N3383A-02

S E R V I C E N O T E

N3383A PNA Microwave Network Analyzers

Figure 1: A3 Front Panel Interface Board Assy without the Bracket

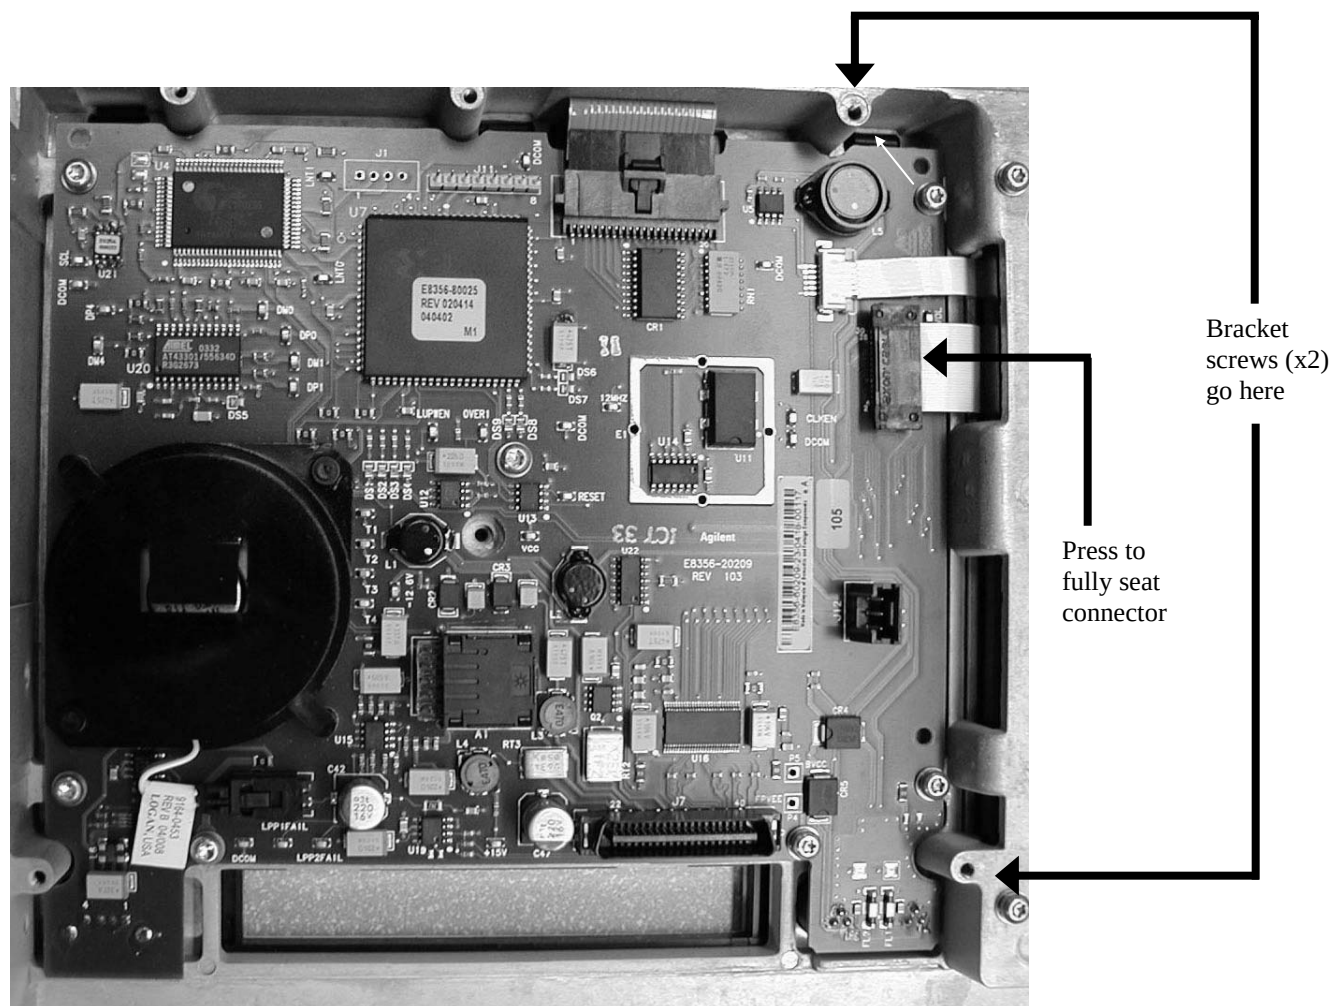
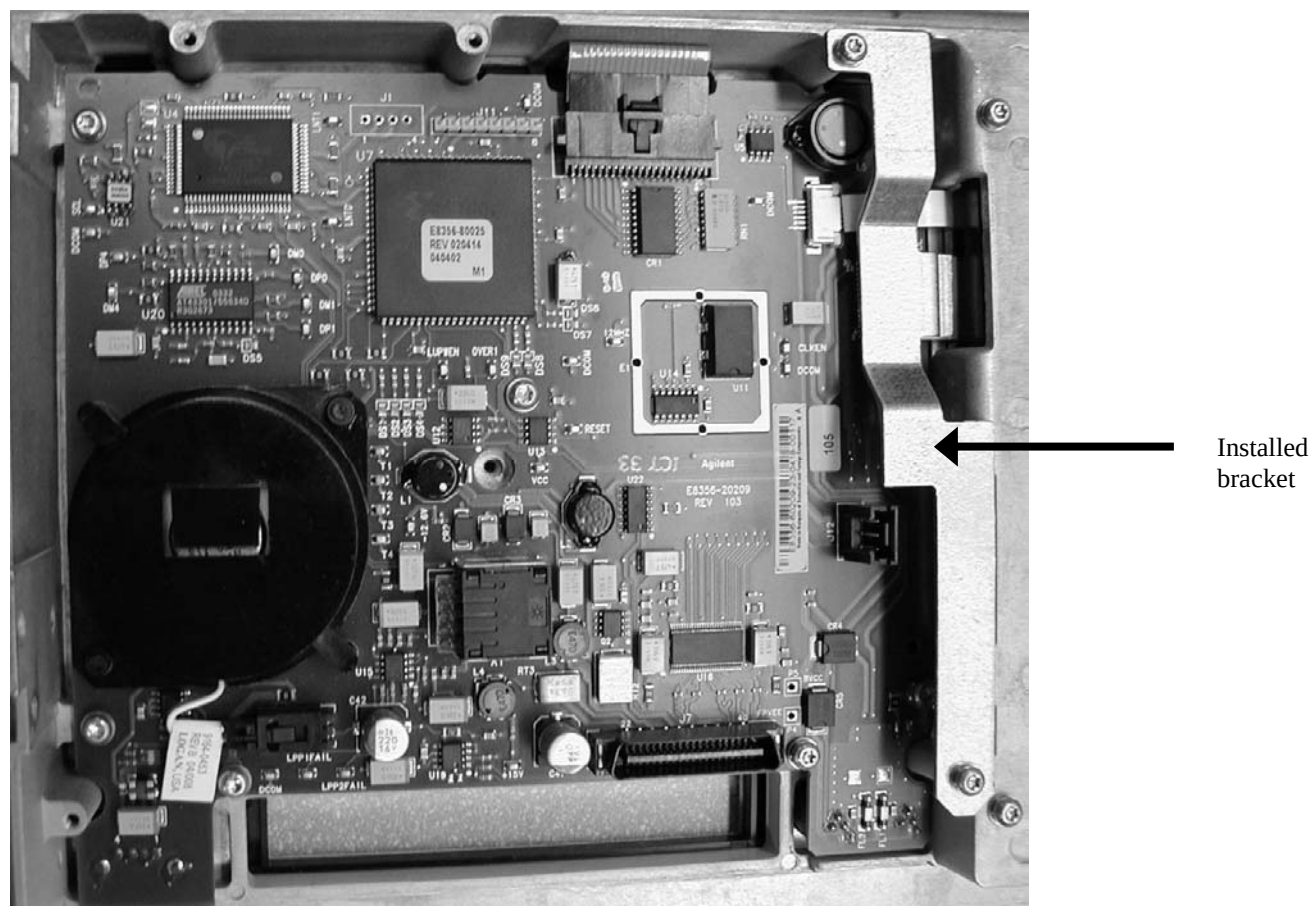
A connector of the ribbon cable (Agilent part number 8120-8409) that joins the front panel display to the front panel interface board can loosen, causing a display failure, unless a new bracket is installed. Because the failure rate has been very low, it is recommended that the bracket be installed only when there is an additional reason to remove the PNA front panel.

1. Refer to Figure 1 in this document:
 - Press down firmly on the ribbon cable's black connector.
 - Locate the two tapped holes for the bracket screws.
2. As shown in Figure 2 in this document, position the bracket so that its holes line-up with the two holes you located in the previous step.
3. Hand-start the two screws, and then torque both to 9 in-lbs.
4. Reinstall the PNA Front Panel by following the Service Guide instructions in the "Replacement Procedure." This is located on the same page as the "Removal Procedure" used previously in step 7.
